**ADDENDUM NO. 1**

**November 16, 2021**

**PROJECT:** Bus Parking Improvements  
I&A Project No.: 1162-004-01

**OWNER:** Jones County Board of Education

PAVING LAYOUT

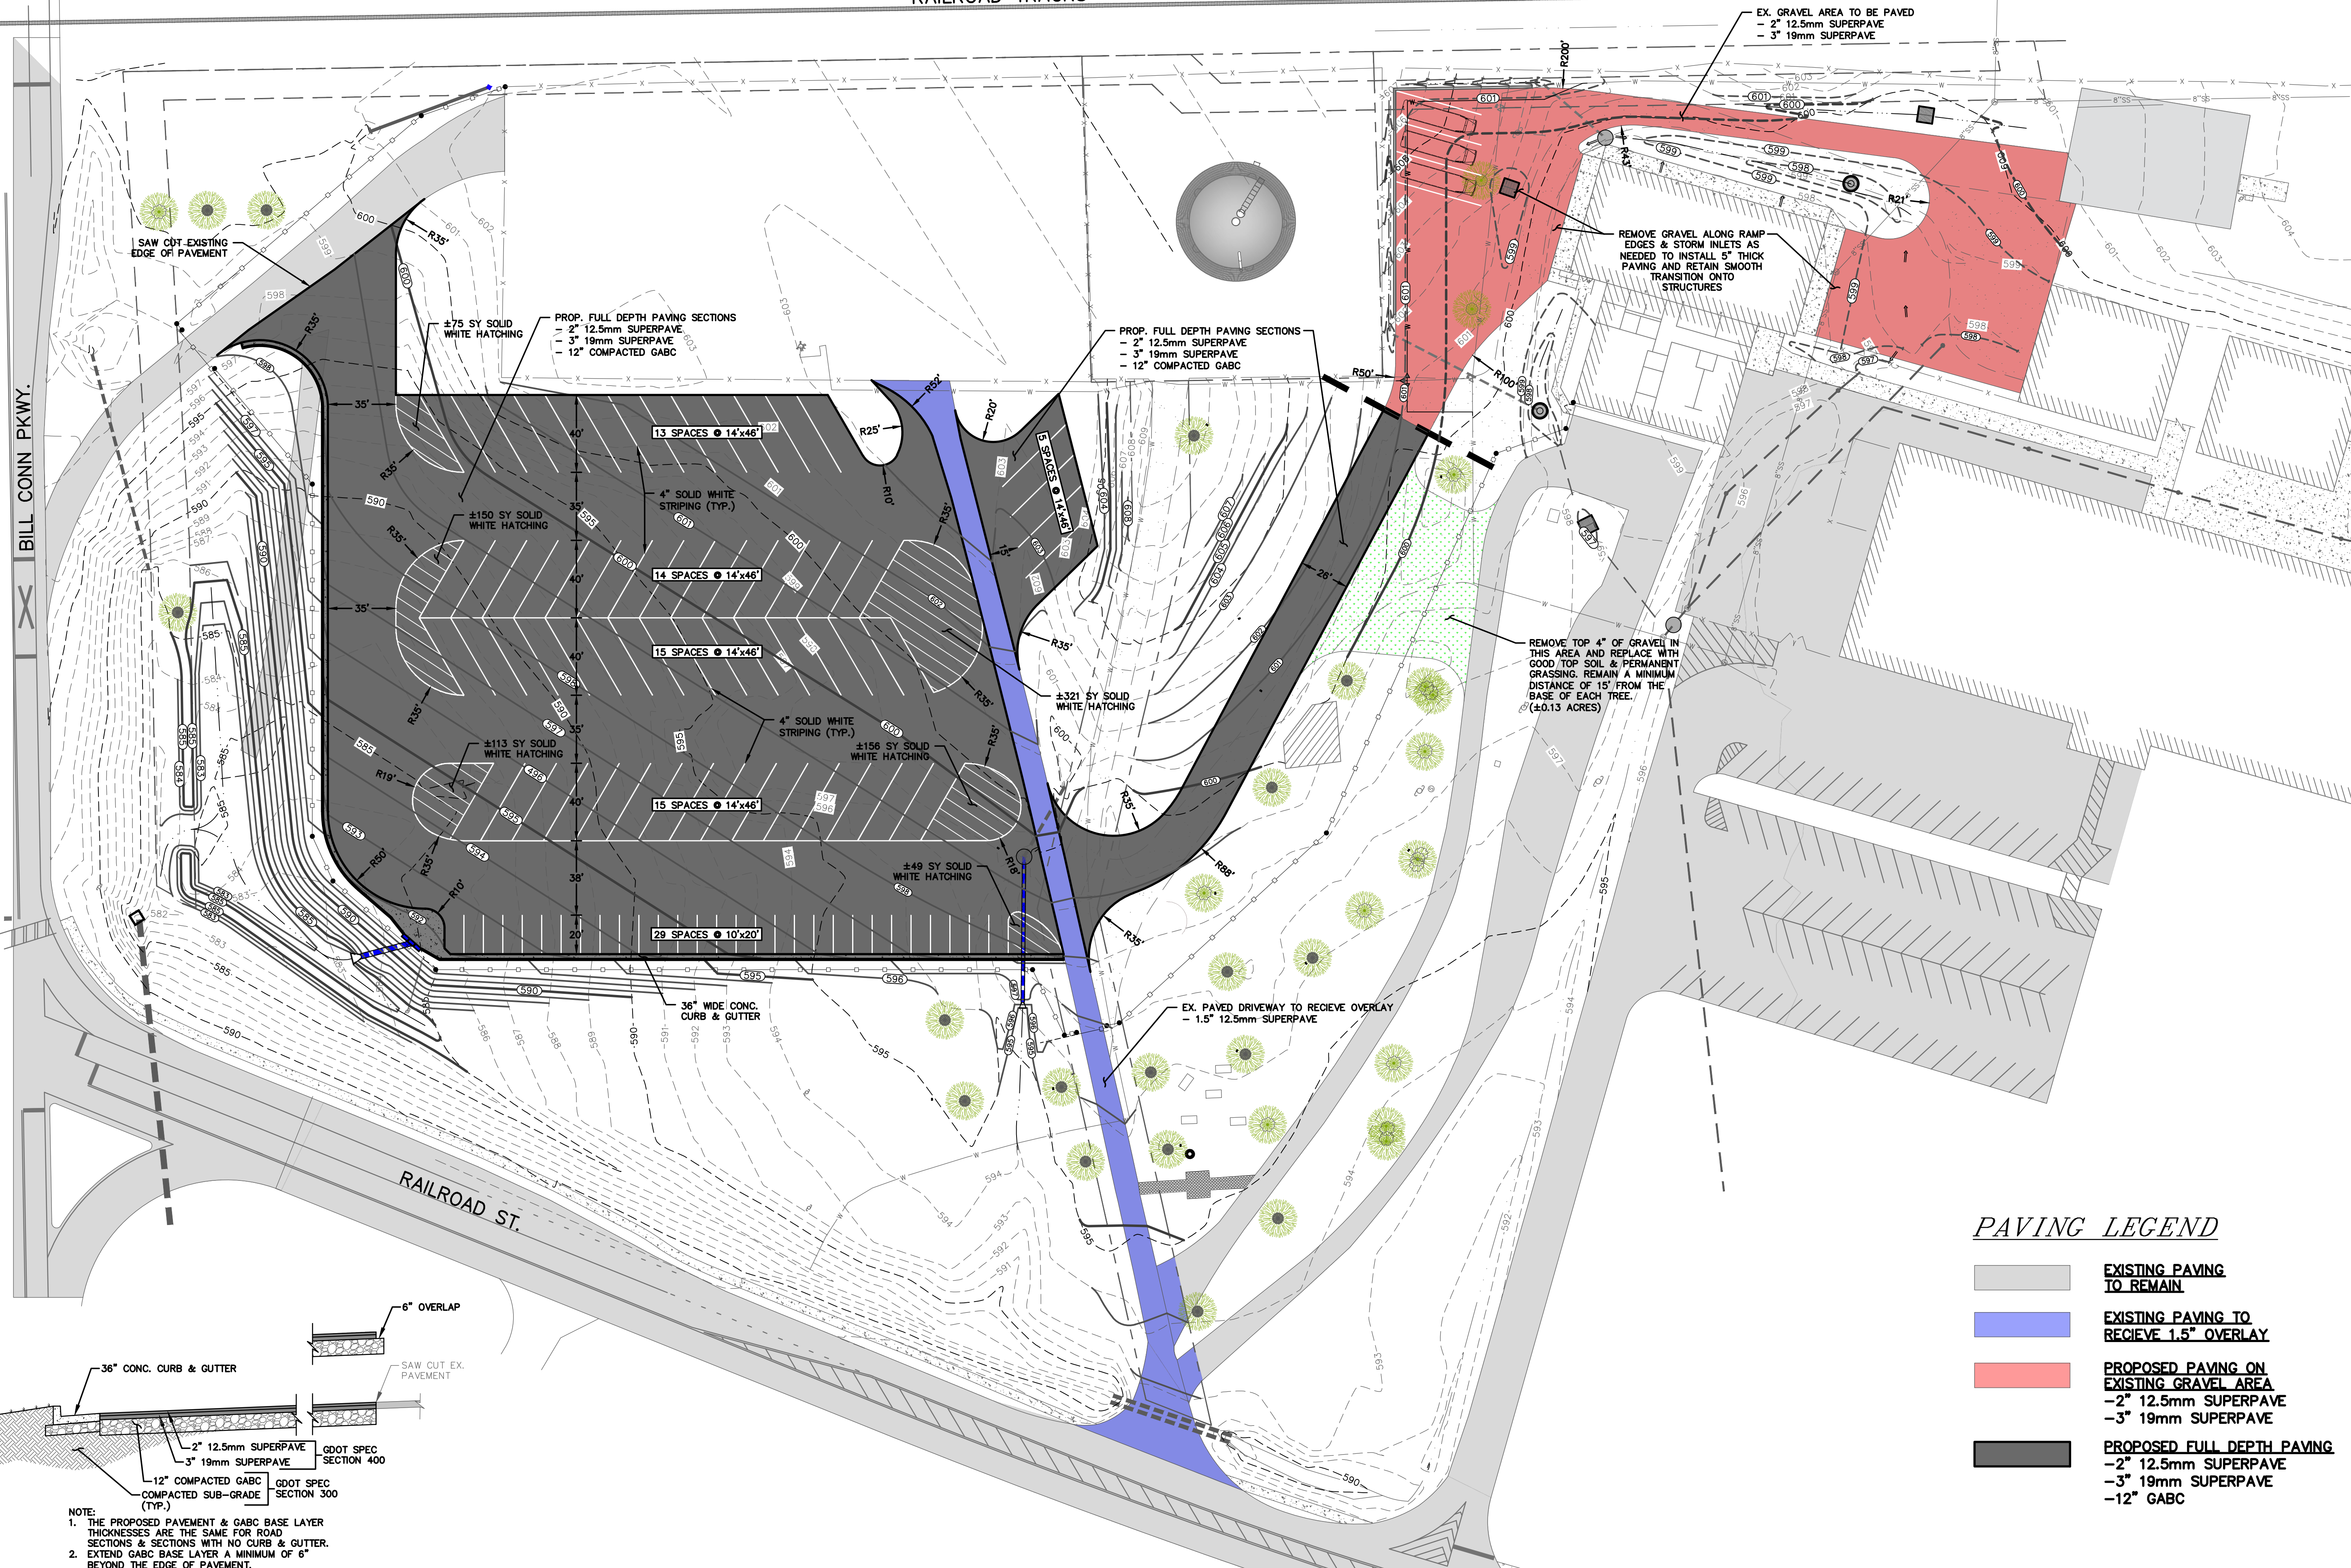
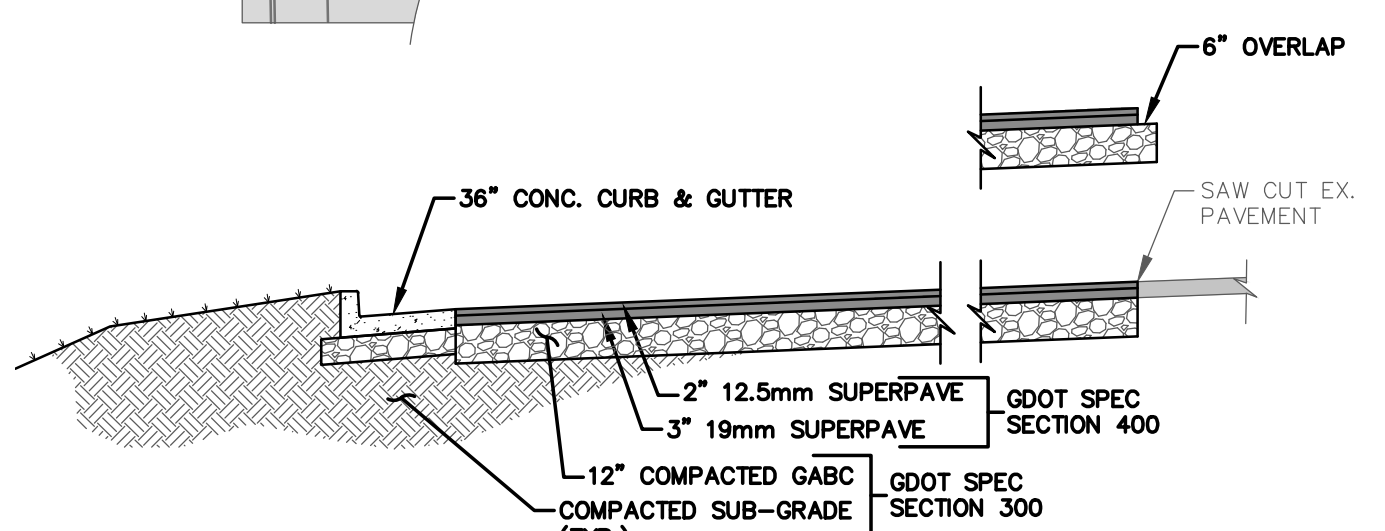
**Item 2: INCLUDE the attached Paving Layout showing all areas to be paved.**

EX. GRAVEL AREA TO BE PAVED  
 - 2" 12.5mm SUPERPAVE  
 - 3" 19mm SUPERPAVE

PROP. FULL DEPTH PAVING SECTIONS  
 - 2" 12.5mm SUPERPAVE  
 - 3" 19mm SUPERPAVE  
 - 12" COMPACTED GABC

REMOVE TOP 4" OF GRAVEL IN THIS AREA AND REPLACE WITH GOOD TOP SOIL & PERMANENT GRASSING. REMAIN A MINIMUM DISTANCE OF 15' FROM THE BASE OF EACH TREE. (±0.13 ACRES)

EX. PAVED DRIVEWAY TO RECIEVE OVERLAY  
 - 1.5" 12.5mm SUPERPAVE
